4 (3)

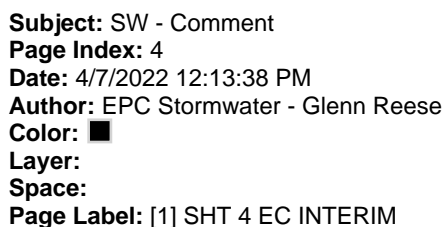
Grading needs to be 50' from existing channel.
